RE: **Project No. SP 17-12 TFD Roof Replacements Fire Station #5 – TFD
Headquarters – EMS Building**

**ADDENDUM NO. 1
TO
PROJECT NO. SP 17-12
TULSA FIRE DEPARTMENT ROOF REPLACEMENTS
TFD-HEADQUARTERS-EMS BUILDING
STATION #5**

Addendum #001

Project: City of Tulsa
Tulsa Fire Department Roof Replacements
TFD Headquarters – EMS Building – Station #5
Project No.: SP 17-12

1 ROOF PLAN
1/4" = 1'-0"

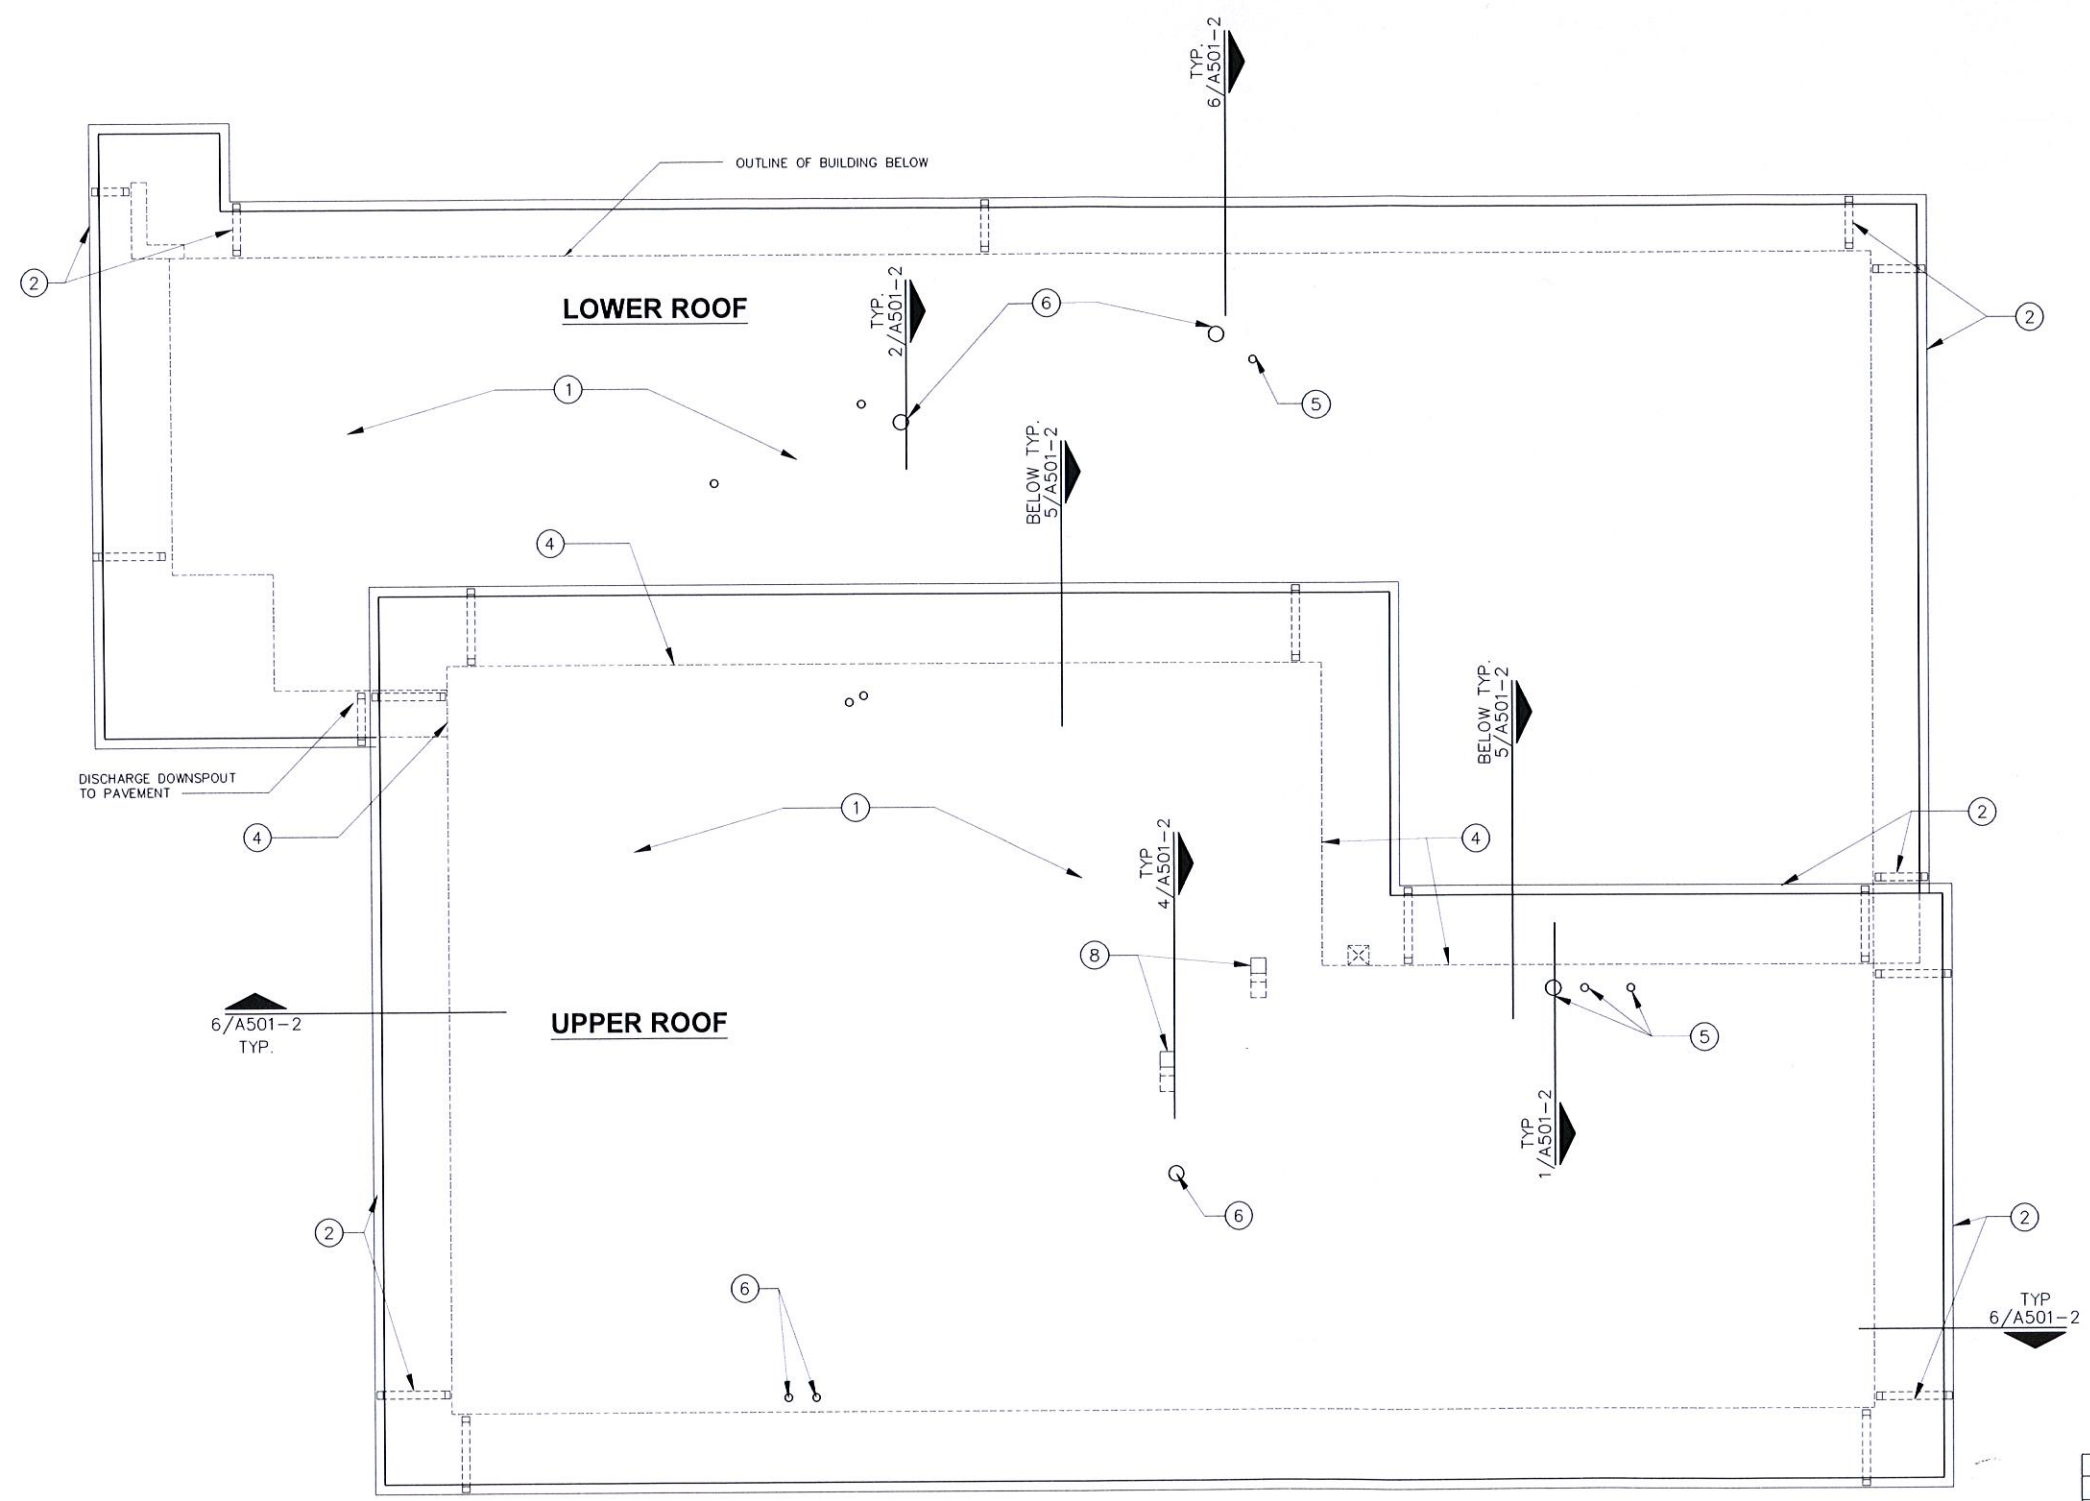
1. Sheet A102-2 Roof Plan

Regarding the EMS building on sheet A102-2 general note #7 indicates R-25 insulation under the tapered. This is approximately 4.5" of insulation. In Keynote #1 is indicates a base layer of 1.5" of insulation. Please advise as to which it should be.

RESPONSE: The R-25 base layer of poly iso is required. Keynote #1 revised deleting reference to 1 1/2" thickness.

- INSTALL FULLY ADHERED 80 MIL TPO ROOFING SYSTEM OVER 1/4" DENSDECK OR HIGH IMPACT RECOVERY BOARD. INSTALL 1/4" PER FOOT TAPERED POLY ISO INSULATION SYSTEM TO DIRECT WATER TO EXISTING ROOF DRAINS. INSTALL BASE LAYER OF POLY ISO INSULATION OVER EXISTING DECK.
- INSTALL 4"x4" GUTTERS AND 4"x4" DOWNSPOUTS WITH PRE-FINISHED METAL COLOR - BERRIDGE CHARCOAL GREY. PROVIDE NEW CONCRETE SPLASH BLOCKS AT ALL TERMINATIONS AT LOWER ROOF AND AT GRADE, UNLESS NOTED OTHERWISE.
- NOT USED.
- INSTALL 1/4" COVER BOARD OVER EXISTING BITUMEN MASTIC AT BASE FLASHINGS. INSTALL BASE FLASHING AND COUNTERFLASHINGS.
- INSTALL FLASHING BOOTS AT ALL PLUMBING PENETRATIONS, RAISE PLUMBING VENTS AS REQUIRED TO MEET MINIMUM HEIGHT ABOVE ROOFING REQUIRED FOR WARRANTY.
- REPLACE ALL FLUE CAPS WITH NEW.
- NOT USED.
- INSTALL ALL NEW AIR DUCTWORK TO MATCH EXISTING. PROVIDE BIRD/INSECT SCREENS.
